State of Washington  
POLLUTION LIABILITY INSURANCE AGENCY  
*PO Box 40930 • Olympia, Washington 98504-0930*  
*(360) 407-0520 • (800) 822-3905*  
*www.plia.wa.gov*

**Re: No Further Action at the Following Site:**

- **Facility/Site (owner) Name:** 3420 E Marginal Way South
- **Facility/Site Address:** 3420 E Marginal Way South, Seattle, WA 98134
- **Facility Site ID (TAP only):** 66253
- **Technical Assistance Program No.:** PNW183

**Issue Presented and Opinion**

## Figure 2: Soil Excavation Map

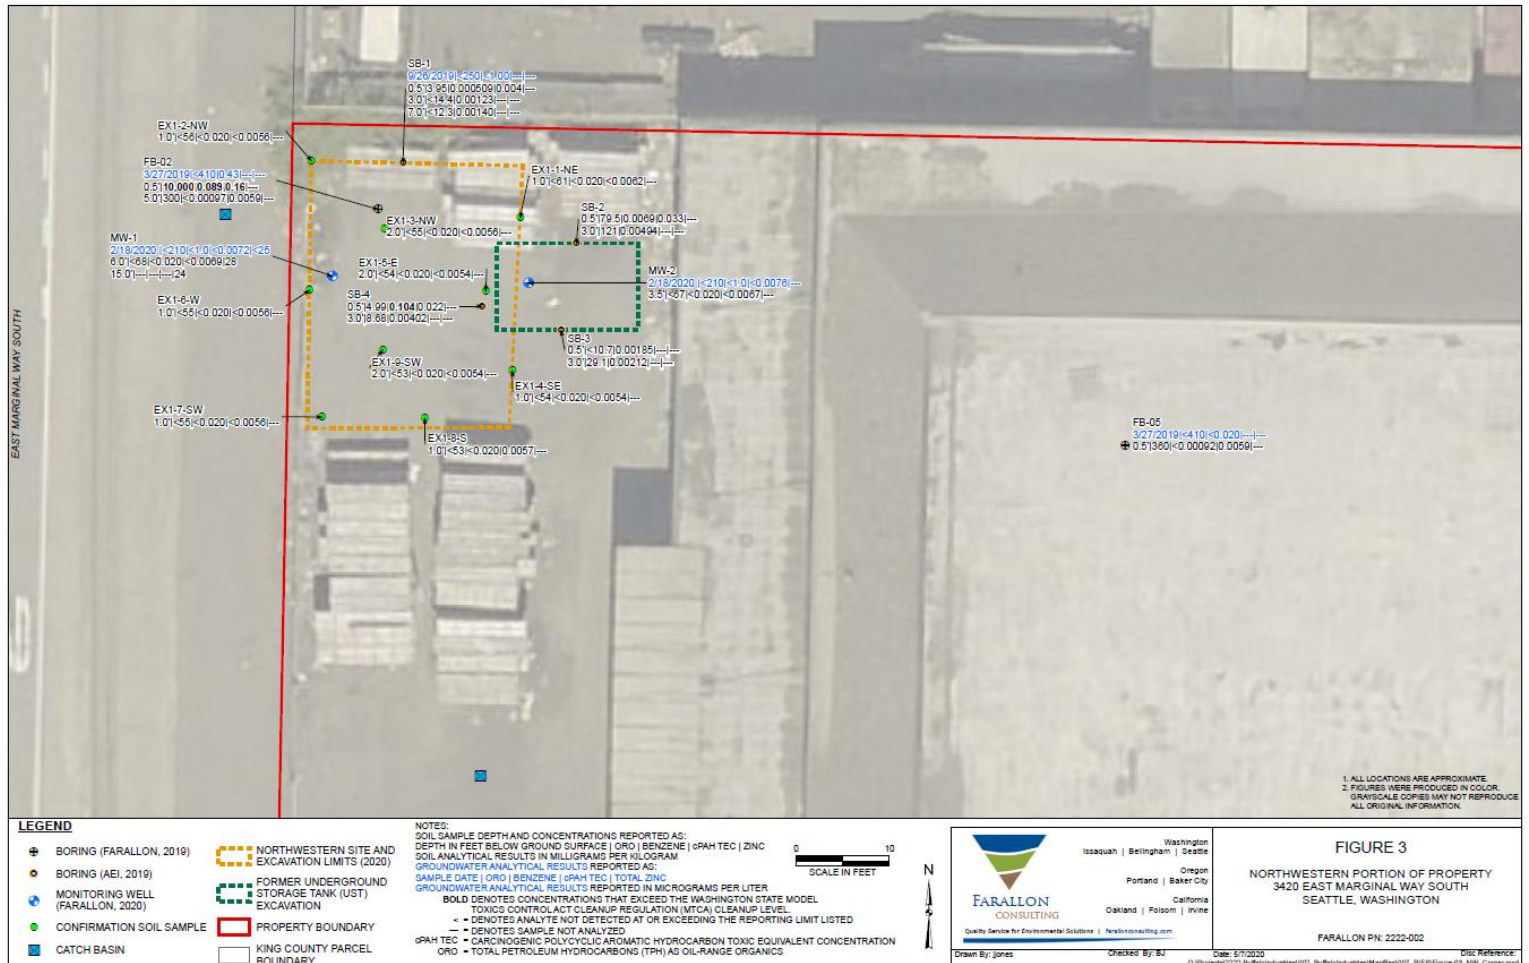
- Petroleum contaminated soil (PCS) at the Site was reportedly associated with a former 1,000-gallon underground storage tank which was located on the northwestern portion of the Property beginning in 1949 (Figure 2). PCS was detected above MTCA Method A CULs in the form of TPH-o and benzene within the depths (0' to 15' below ground surface [bgs]) that humans are most likely to come into contact (Table 1).

- A total of four groundwater monitoring wells were installed at the Site. Groundwater flow direction was determined to be generally east-southeast. No COCs were detected above MTCA Method A CULs in four groundwater monitoring wells installed to assess groundwater conditions at the Site (Figure 2).

- A warehouse building footprint is within the lateral inclusion zone (30') and vertical separation distance (15') of historical petroleum related detections above MTCA Method A CULs (Figure 2).

- Excavation and disposal of 61.3 tons of PCS during an interim action excavation in February 2020.
- Confirmation soil sampling was performed to determine if all PCS above MTCA Method A CULs had been removed from the Site (Table 2).

- The soil remedial action, subsequent confirmation soil sampling, and the installation and sampling of four groundwater monitoring wells served to close the soil leaching to groundwater exposure pathway. The groundwater data from Site monitoring wells indicates that all contaminants of concern are below CULs at the Site.
